RESPONSE TO REQUEST FOR ADDITIONAL INFORMATION

US-APWR Design Certification

RAI NO.: NO. 1044-7140 REVISION 3
SRP SECTION: 03.08.04 – Other Seismic Category I Structures
APPLICATION SECTION: 3.8.4
DATE OF RAI ISSUE: 07/08/2013

QUESTION NO. 03.08.04-55:

Figure 1. Fuel Handling Area Pits

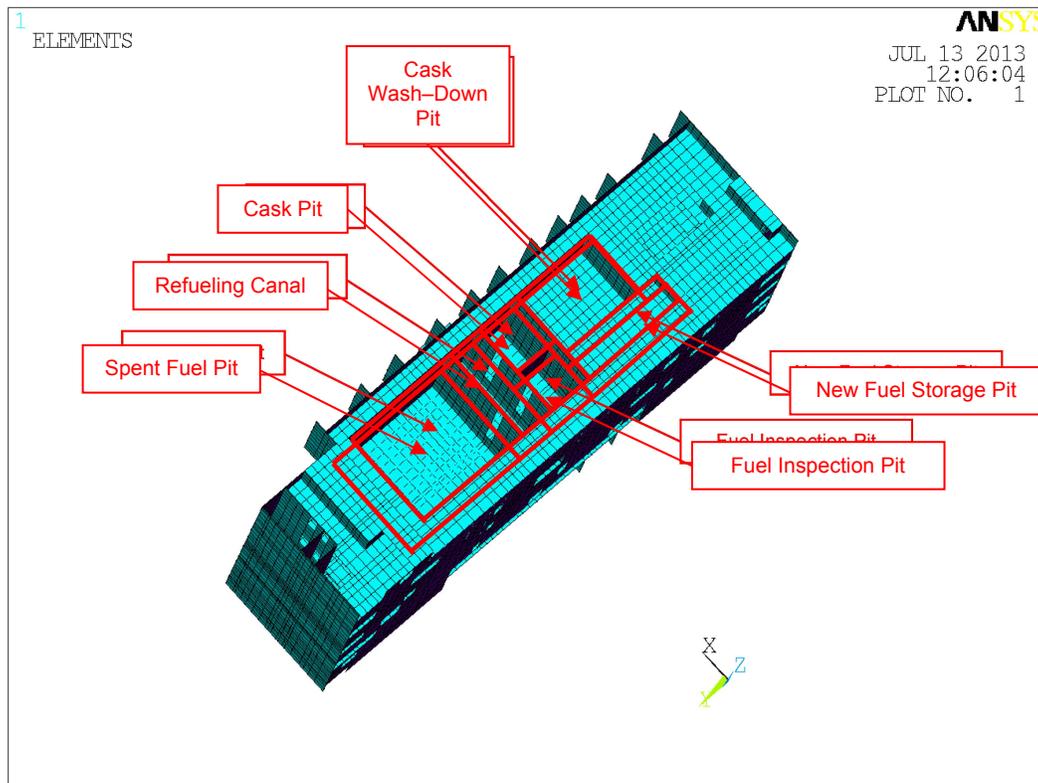
The applicant is requested to provide figures depicting the design for the areas of the fuel handling, the new and spent fuel storages, and the structural steel framing supporting system to the areas; and describe how the loads from these areas are transferred down to the basemat during an earthquake.

Loads were applied to the fuel handling area pits in the ANSYS model in two ways: (1) loads from water, and (2) loads from equipment. The water weight in the pits was applied to slabs using MASS21 elements. Static and dynamic pressure from the water was applied to the surrounding walls of each pit. Loads from equipment inside the pits were applied by changing the density of the slab elements in the locations of those pieces of equipment. These loads include pumps, fuel storage racks (new fuel, damaged fuel, and spent fuel), structural steel to support fuel racks, spent fuel, damaged fuel, damaged fuel container, fuel transfer system, new fuel elevator, and pit gates. For the fuel storage racks, in the ANSYS model, an evenly distributed load was applied over the slab area where all the individual racks reside. Figure 1 shows the layout of the fuel handling area pits in the ANSYS model.
